**SUNDRY NOTICES AND REPORTS ON WELLS**  
*Do not use this form for proposals to drill or to re-enter an abandoned well. Use form 3160-3 (APD) for such proposals.*

8. Well Name and No.  
FEDERAL 29-12-24 101

**Wellbore Plugging Plan**

**Federal 29-12-24 #101  
Plugging & Final Abandonment**

# Federal 29-12-24 #101

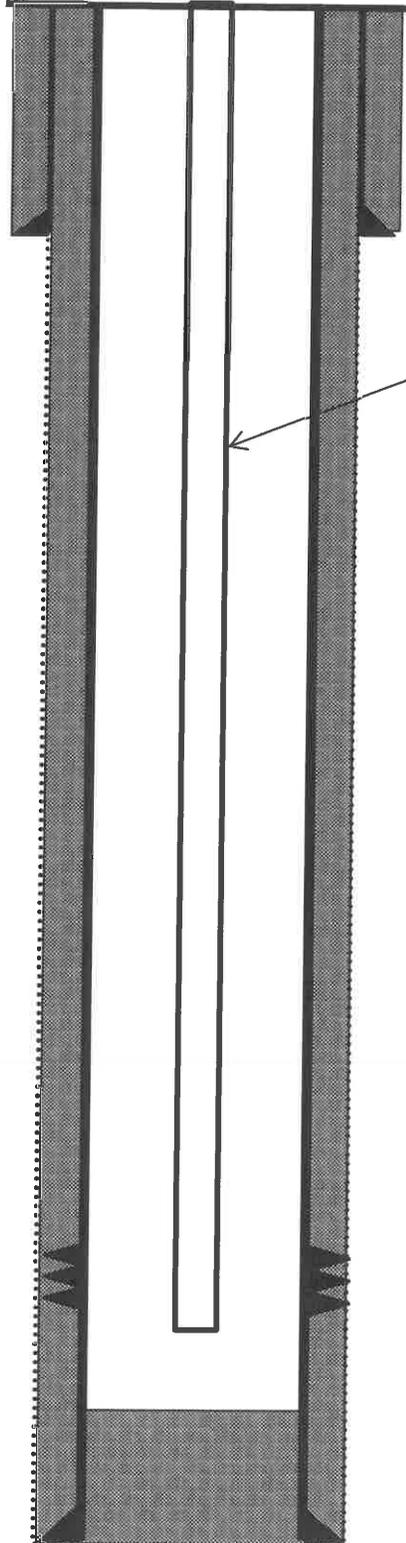
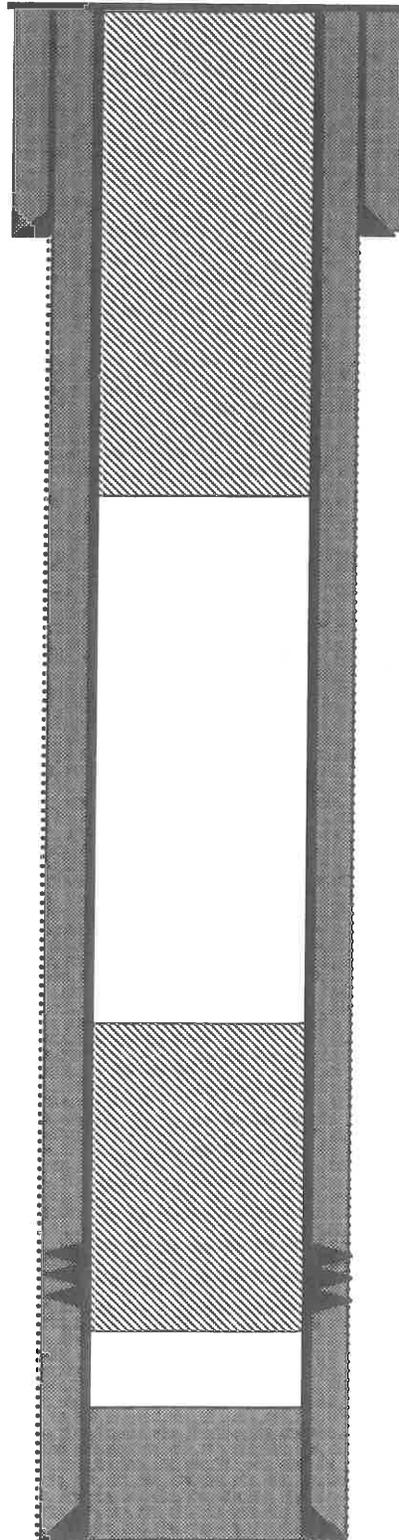
- Please ensure that the tops of the Pictured Cliffs and Fruitland formations as well as the entire Ojo Alamo aquifer, identified in this report, are isolated by proper placement of cement plugs. This will protect the freshwater sands in this well bore.
